PENRITH CITY COUNCIL

MAJOR ASSESSMENT REPORT

Application number:	DA20/0729
Proposed development:	Torrens Title Subdivision of 2 into 3 lots and Construction of Three x Two Storey Boarding House with Associated Fencing, Car Parking, Tree Removal, Landscaping and Drainage Works
Property address:	32 Park Avenue, KINGSWOOD NSW 2747 31 Park Avenue, KINGSWOOD NSW 2747
Property description:	Lot 16 DP 29528 Lot 15 DP 29528
Date received:	5 November 2020
Assessing officer	Lucy Goldstein
Zoning:	SEPP WSA - Affected by Obstacle Limitation SEPP WSA - Affected by Wildlife Buffer Zone Zone R3 Medium Density Residential - LEP 2010
Class of building:	Class 1b
Recommendations:	Refuse

NOTE: BELOWGROUND STORAGE FOR OSD 2 SECTION DETAILS TO BE SHOWN ON CC DRAWINGS

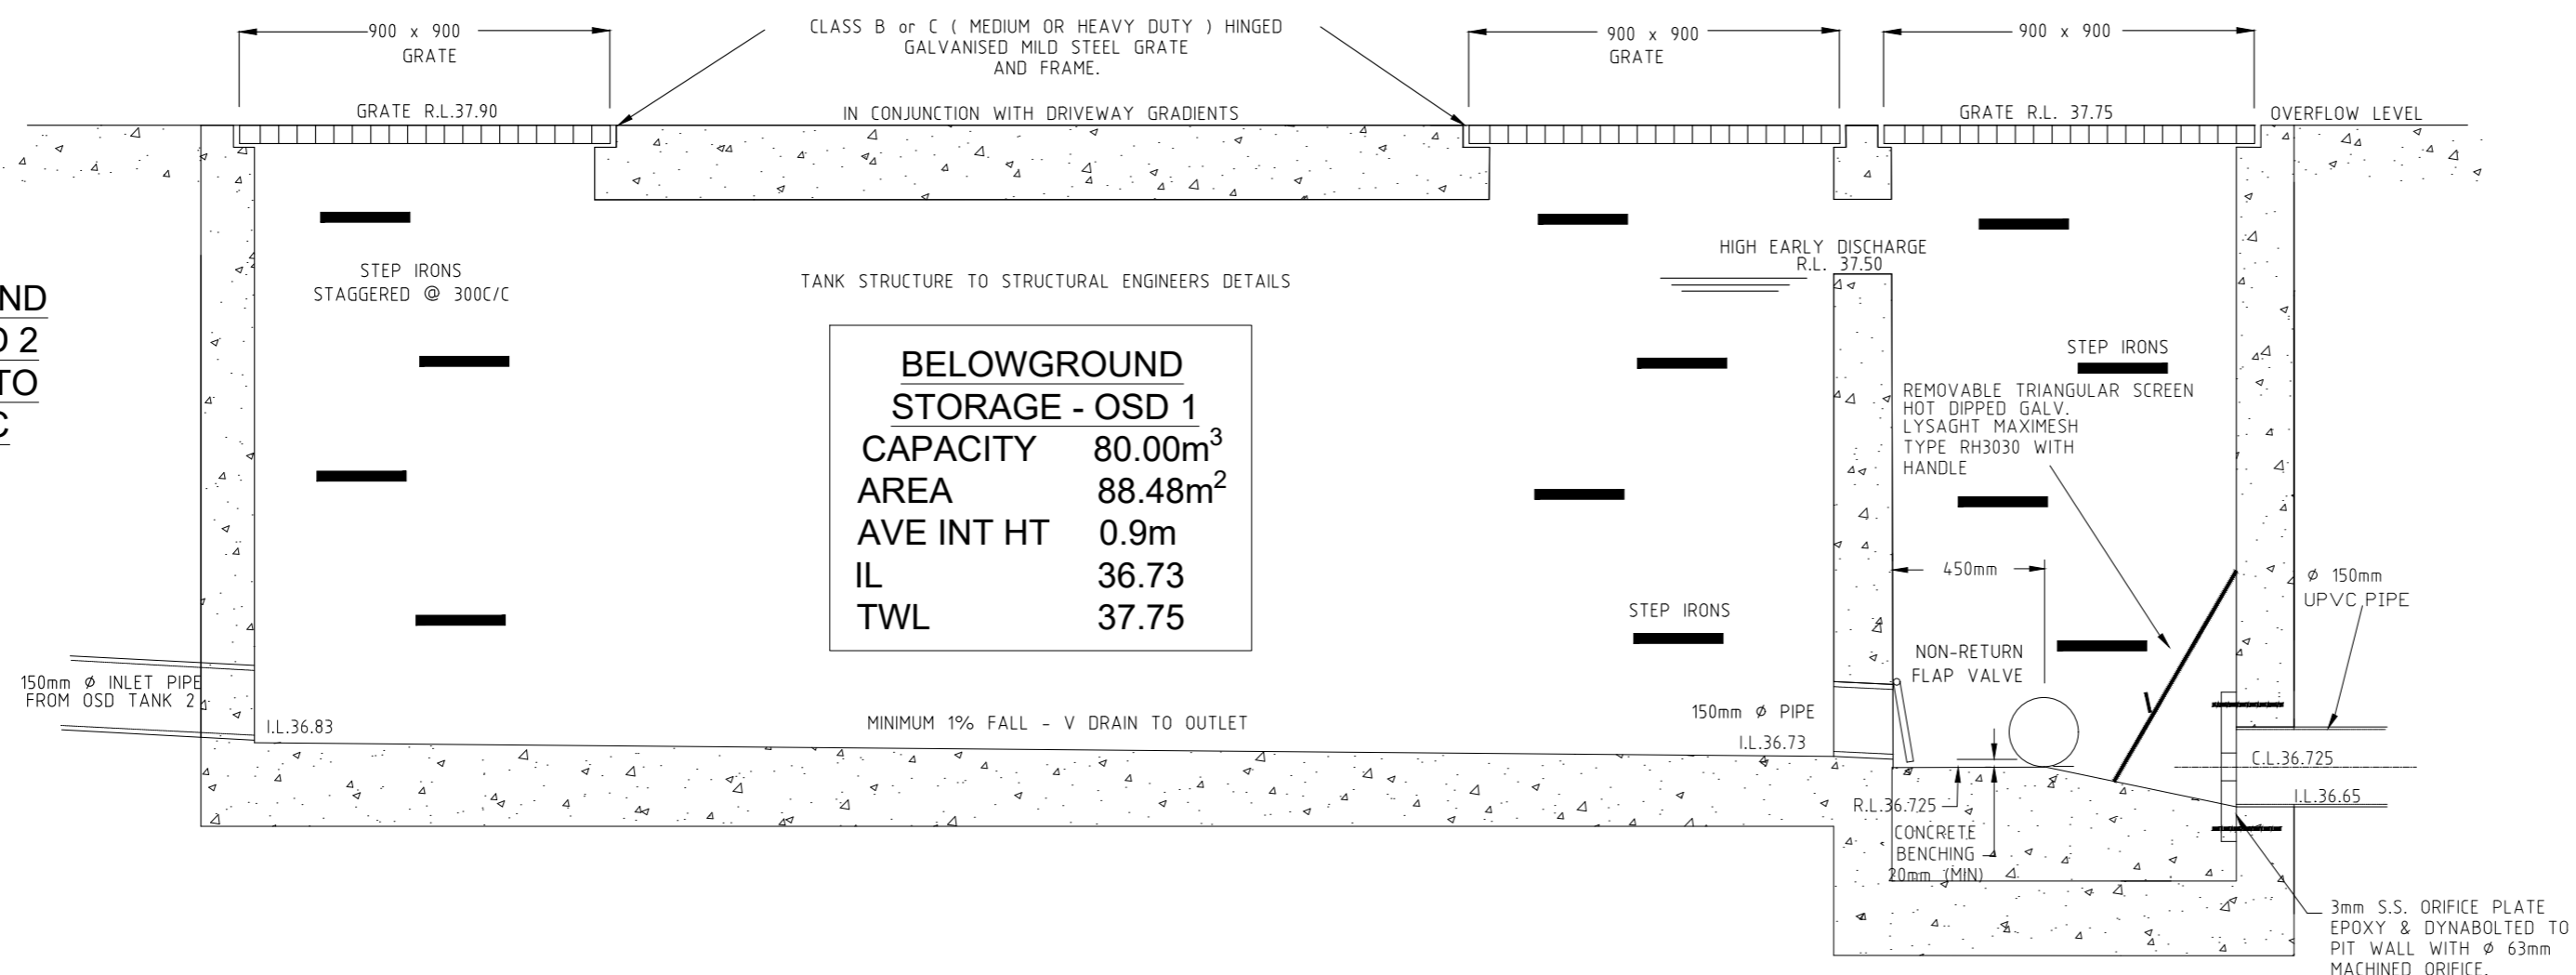
In this regard, the Drainage Plan shows stormwater lines traversing between lots and OSD systems encroaching between lots. Given that Torrens Title Subdivision is proposed, all private drainages lines are required to be wholly contained within each lot, with a single inter-allotment drainage line and easement for drainage discharging to the street where required. In addition, a separate OSD system is required to be provided per lot, wholly contained within the lot. OSD storage cannot be split or stored between lots.

The Drainage Plan shows stormwater lines traversing between lots and Onsite Detention (OSD) systems encroaching between lots. Given that Torrens Title Subdivision is proposed, all private drainages lines are required to be wholly contained within each lot, with a single inter-allotment drainage line and easement for drainage discharging to the street where required. In addition, a separate OSD system is required to be provided per lot, wholly contained within the lot. OSD storage cannot be split or stored between lots. OSD calculations shall be demonstrated for each lot, including SSR, PSD and bypass area specific to each lot.

The Drainage Plan shows stormwater infrastructure traversing between lots. Given that Torrens Title Subdivision is proposed, all drainage infrastructure is required to be wholly contained within each lot. Refer to discussion in this report under 'Likely Impacts'.
